Type Coffee Vending Machine	Model 95	N° T.I. 06 - 2023
Serial Number 24024490	Subject CAPACITIVE KEYBOARD WITHOUT GIGABIT PORT	ISSUED FOR (X) Action Information X

CUP board detail

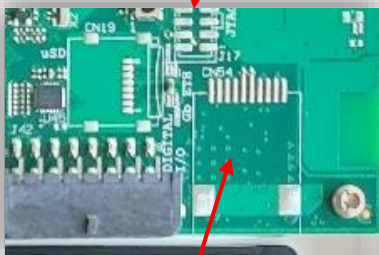
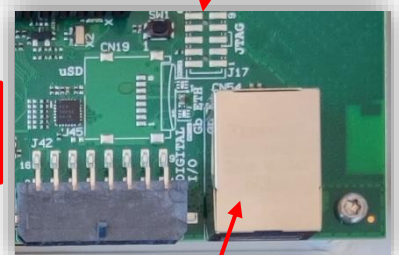
Since the Ethernet connection is now little used unlike Wifi and 4G solutions, the *Ethernet port* and its *chip* have been removed from the CPU board, contained in capacitive keyboards.

Ethernet port has been removed

Modified CPU board (Bottom view)

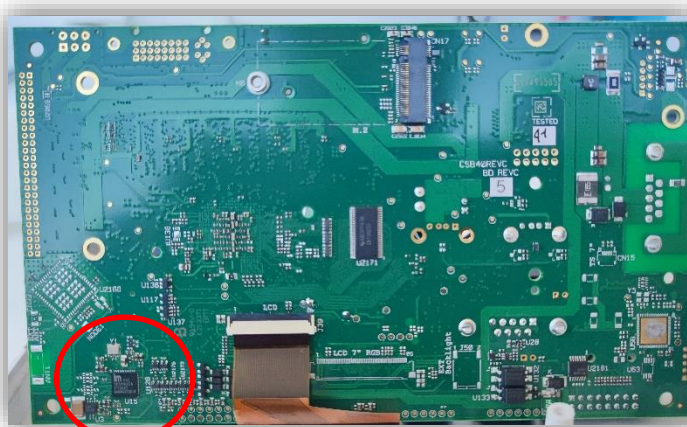
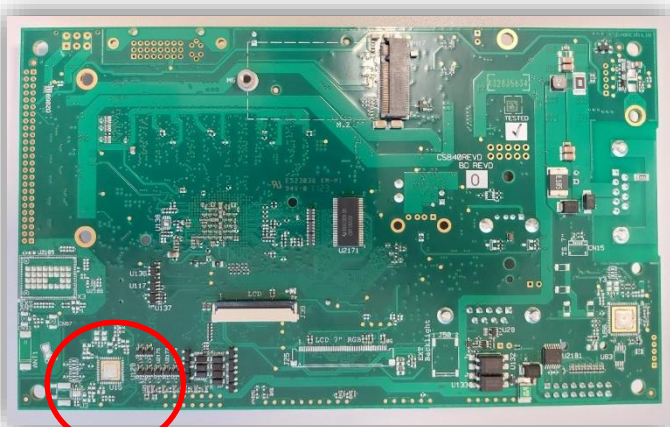
Chip removed
